UNITED STATES PATENT AND TRADEMARK OFFICE

APPLICATION NO.	FILING DATE	FIRST NAMED INVENTOR	ATTORNEY DOCKET NO.	CONFIRMATION NO.
09/700,464	11/15/2000	Terunao Hanaoka	107284	5910

Office Action Summary	Application No. 09/700,464	Applicant(s) HANAOKA ET AL.	
	Examiner Leonardo Andújar	Art Unit 2826

DETAILED ACTION

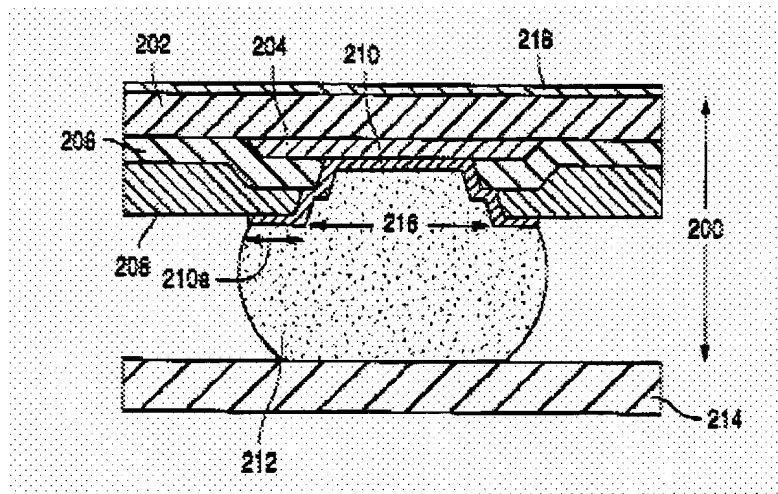
3. Claims 13, 22 and 24 are rejected under 35 U.S.C. 112, first paragraph, as failing to comply with the written description requirement. The claim(s) contains subject matter which was not described in the specification in such a way as to reasonably convey to one skilled in the relevant art that the inventor(s), at the time the application was filed, had possession of the claimed invention. The specification as originally filed does not disclose that the uppermost layer of the insulating layers (i.e. top single layer) has protrusions and depression. Note that the protrusions and depression are formed by the plurality of layers and not by a single layer.

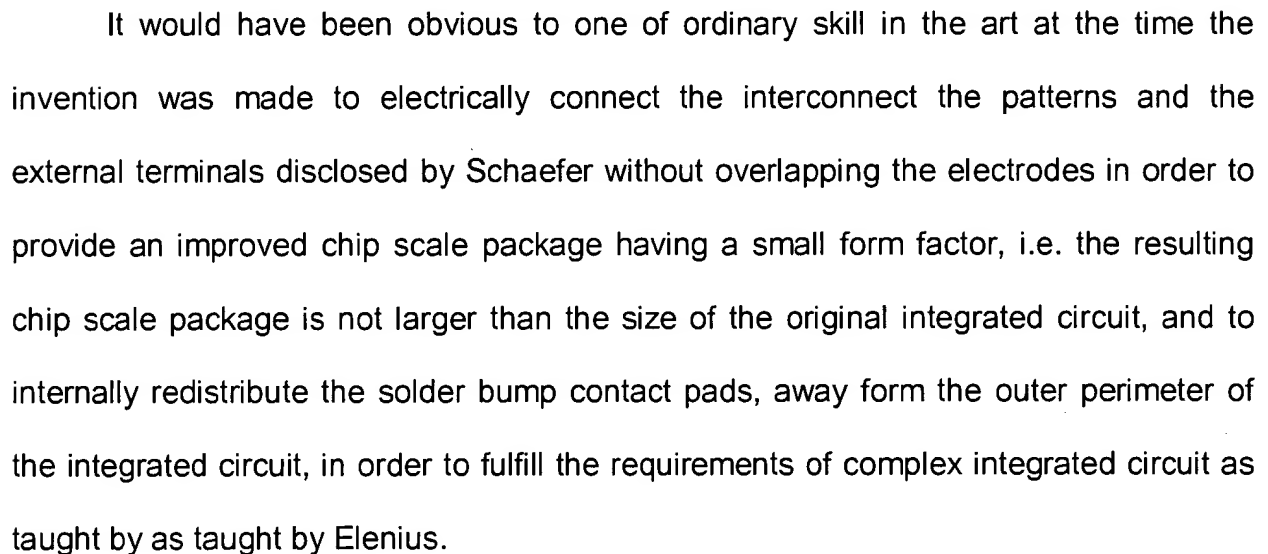
7. Elenius (e.g. figs. 1 and 2) shows a semiconductor device including a semiconductor element 14 having external terminals 28 electrically connected to a interconnect pattern 30 without overlapping electrodes 18. According to Elenius this type of embodiment provides an improved chip scale package that has a small form factor, i.e. the resulting chip scale package is not larger than the size of the original integrated circuit (col. 3/lis. 16-41). Elenius discloses that the size and the amount of the solder bumps are compromised due to the fact that the solder pads are typically located at the perimeter of the integrated circuit. Elenius discloses that the solder bump contact pads can be redistributed internally, away from the outer perimeter of the integrated circuit; the size of such solder bumps is unchanged. Therefore, the requirements of complex integrated circuits can be fulfilled (col. 2/lis. 25-40).
